Docket No. 50-272

The Commission has issued the enclosed Amendment No. 20 to Facility Operating License No. DPR-70 for the Salem Nuclear Generating Station, Unit No. 1. This amendment consists of changes to the Technical Specifications in response to your request dated March 2, 1979 with additional information dated April 30, 1979, July 25, 1979, August 3, 1979, August 8, 1979, August 9, 1979, and September 14, 1979.

The amendment revises Radiological Safety Technical Specifications related to the Cycle 2 core. These changes involve the axial flux difference, heat flux hot channel factor, nuclear enthalpy hot channel factor and reactor core. This amendment authorizes initiation of operation for Cycle 2.

FIGURE 3.2.2  
 $K(z)$  - NORMALIZED  $F_0(z)$  AS A FUNCTION  
 OF CORE HEIGHT

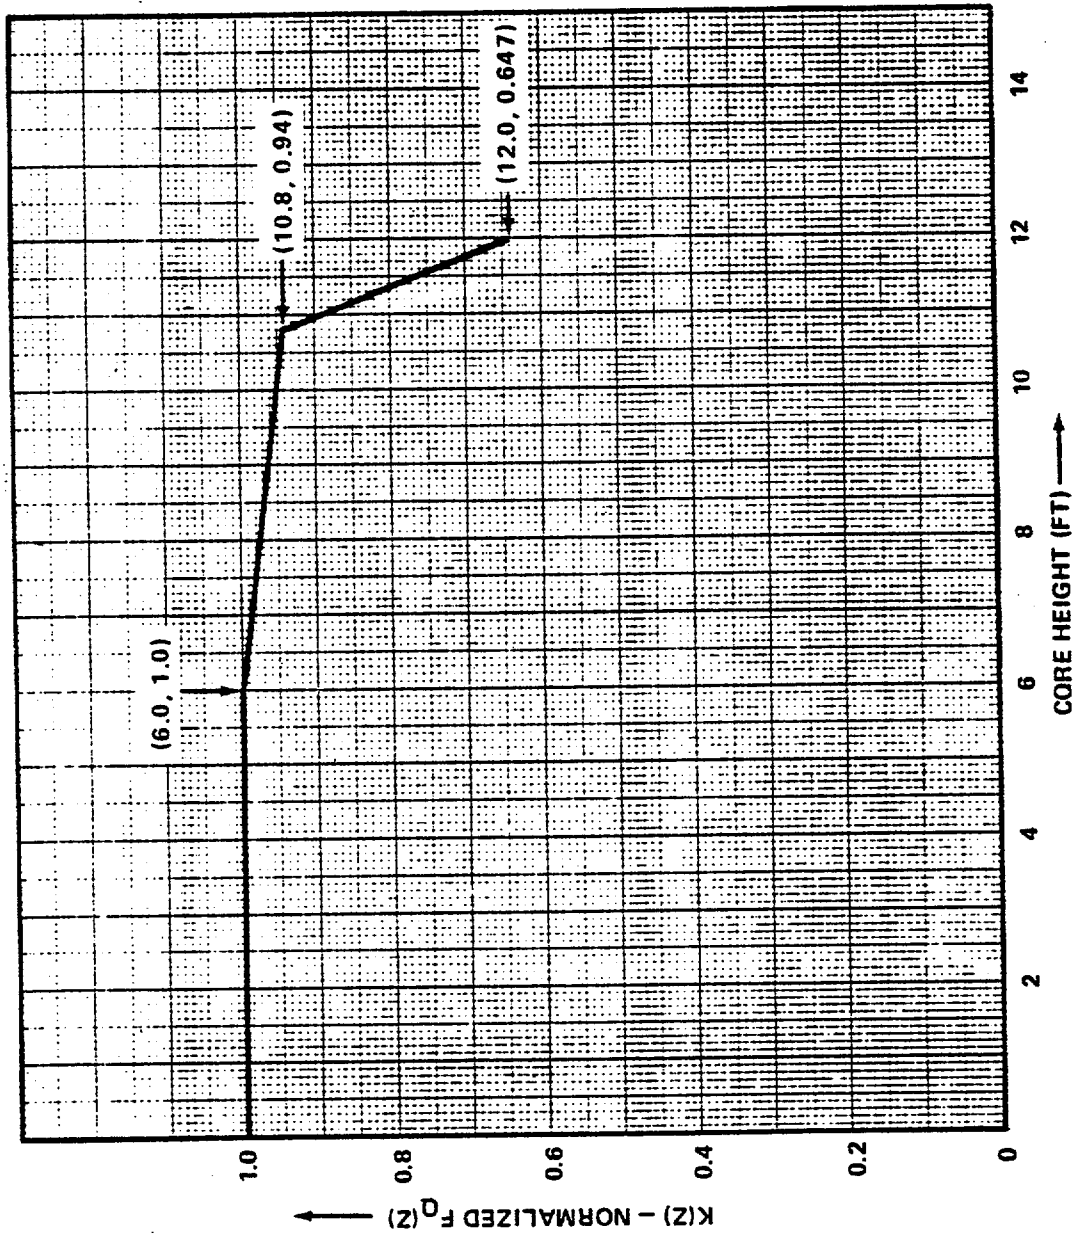
4.2.2.3 When  $F_Q(Z)$  is measured pursuant to specification 4.10.2.2, an overall measured  $F_Q(Z)$  shall be obtained from a power distribution map and increased by 3% to account for manufacturing tolerances and further increased by 5% to account for measurement uncertainty.

Figure 3.2-3  
ROD BOW PENALTY AS A FUNCTION OF BURNUP

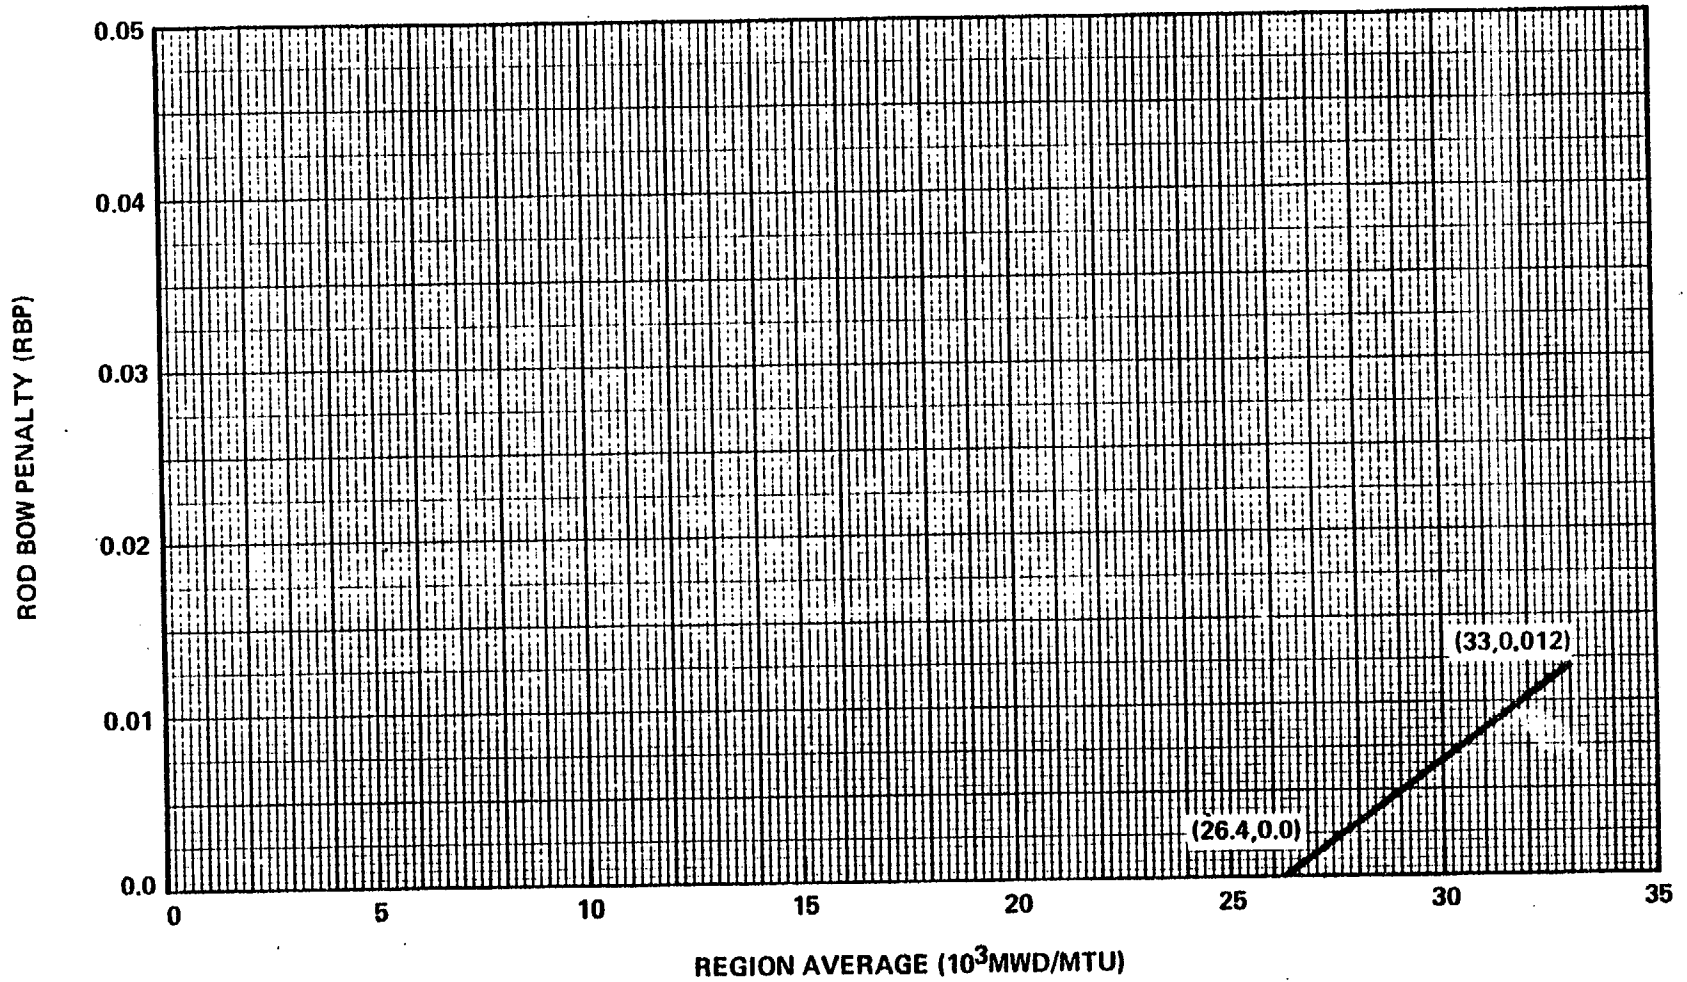
RBP(BU)= Rod Bow Penalty as a function of region average burnup as shown in Figure 3.2-3, where a region is defined as those assemblies with the same loading date (reloads) or enrichment (first core).

Figure B 3/4 2-1 TYPICAL INDICATED AXIAL FLUX DIFFERENCE VERSUS  
THERMAL POWER

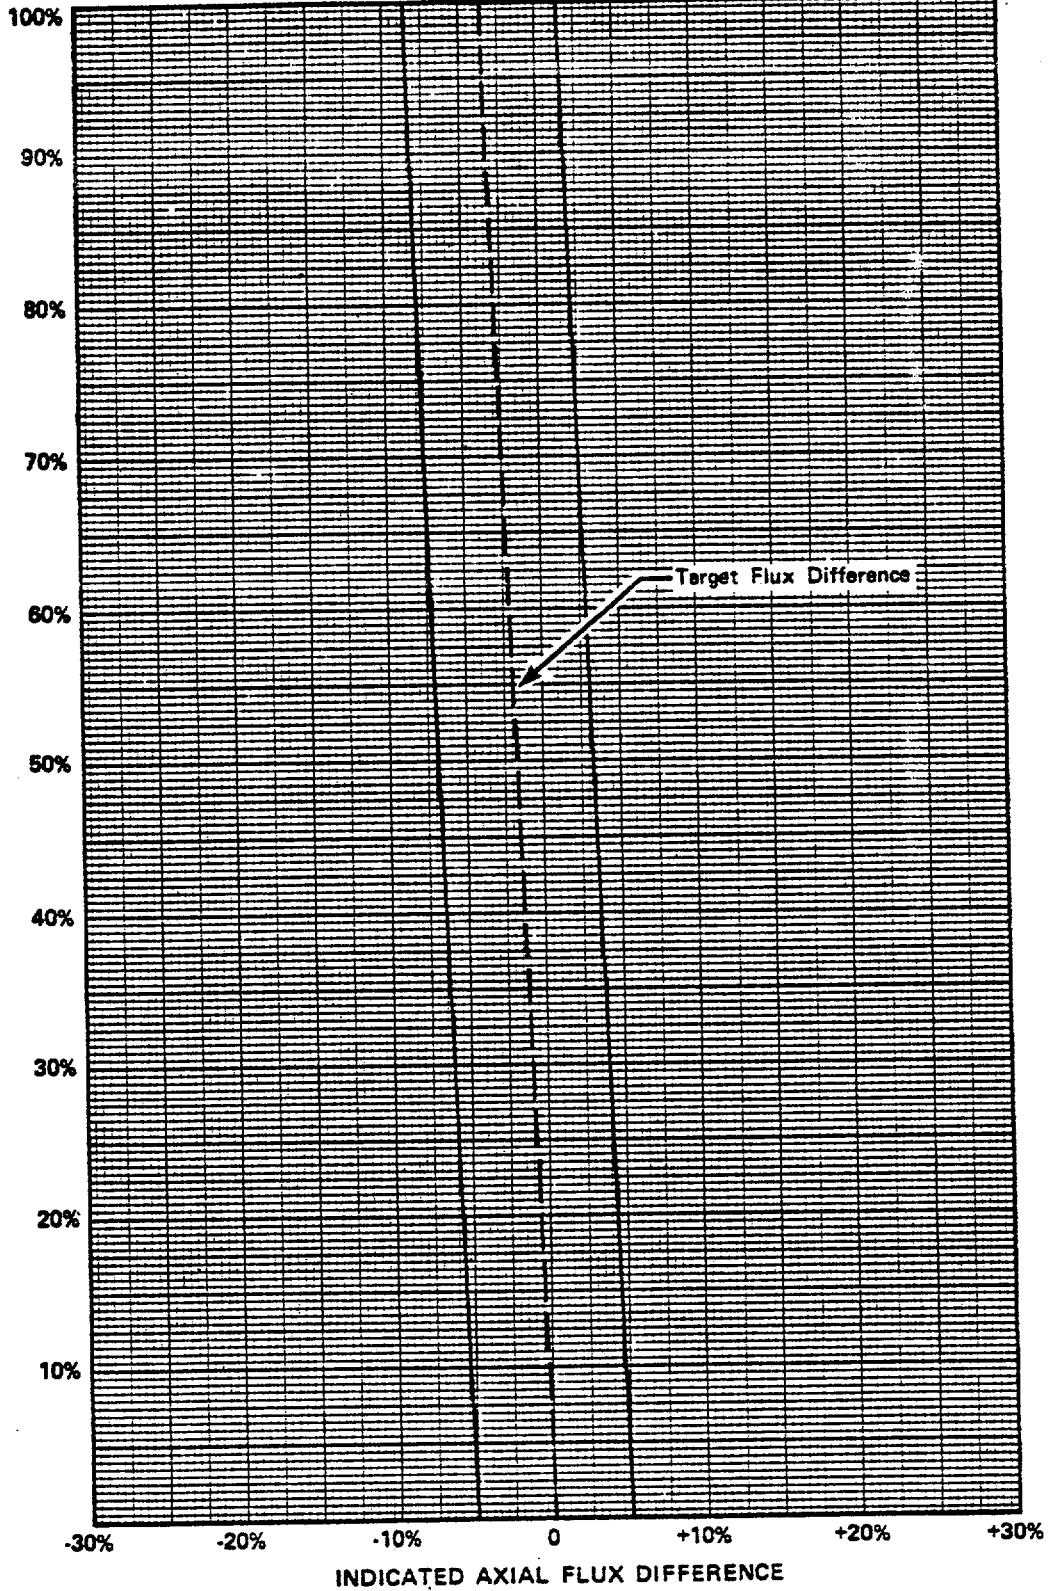
Although it is intended that the plant will be operated with the AXIAL FLUX DIFFERENCE within the +5% target band about the target flux difference, during rapid plant THERMAL POWER reductions, control rod motion will cause the AFD to deviate outside of the target band at reduced THERMAL POWER levels. This deviation will not affect the xenon redistribution sufficiently to change the envelope of peaking factors which may be reached on a subsequent return to RATED THERMAL POWER (with the AFD within the target band) provided the time duration of the deviation is limited. Accordingly, a 1 hour penalty deviation limit cumulative during the previous 24 hours is provided for operation outside of the target band but within the limits of Figure 3.2-1 while at THERMAL POWER levels between 50% and 90% of RATED THERMAL POWER. For THERMAL POWER levels between 15% and 50% of rated THERMAL POWER, deviations of the AFD outside of the target band are less significant. The penalty of 2 hours actual time reflects this reduced significance.

Provisions for monitoring the AFD are derived from the plant nuclear instrumentation system through the AFD Monitor Alarm. A control room recorder continuously displays the auctioneered high flux difference and the target band limits as a function of power level. A first alarm is received any time the auctioneered high flux difference exceeds the target band limits. A second alarm is received if the AFD exceeds its allowable limits for a cumulative time of one hour during any 24 hour time period starting with the occurrence of the first alarm. Time outside the target band is graphically presented on the strip chart.

Figure B 3/4 2-1 shows a typical monthly target band.
